## IMPORTANT SAFETY RECALL

**NHTSA Safety Recall 25V-007**

**SUBJECT: Campaign # 194 – Spare Tire Carrier May Detach**

# Spare Tire Carrier

Figure 1

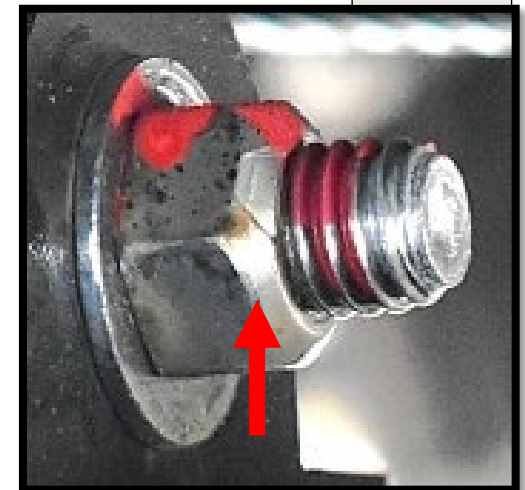
1. Locate the spare tire carrier's brackets where there are 2 separate bolts securing the bottom base of the tire carrier. (See Figure 1 Highlighted in Yellow)
2. Ensure the 2 nuts are Locknuts and NOT the normal bolt nuts. (See Figure 2) Locknuts will have an indent or a punch mark in the middle of a side of the nut. (See Figure 2 Red Arrow)

Figure 3

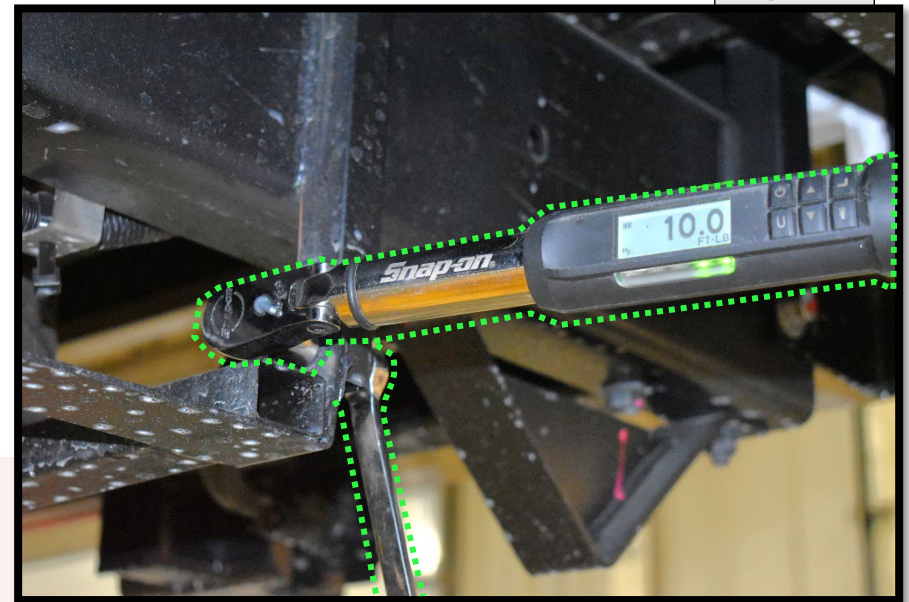
1. Use a torque wrench capable of 10ft/lbs. and a 9/16" socket and place on the nut of the bolt. (See Figure 3)
2. Use a 9/16" backup wrench to hold the head of the bolt to secure it from moving as you torque the nut to the required torque specification 10ft/lbs. (See Figure 3)
3. Repeat the process for the second bolt.
4. Once bolts are torqued correctly, use a torque marker or torque paint to mark the bolt and the surface of the bracket the bolt is on. This will indicate that the bolt was torqued to the proper specification. (See Figure 4 – Orange Marks)
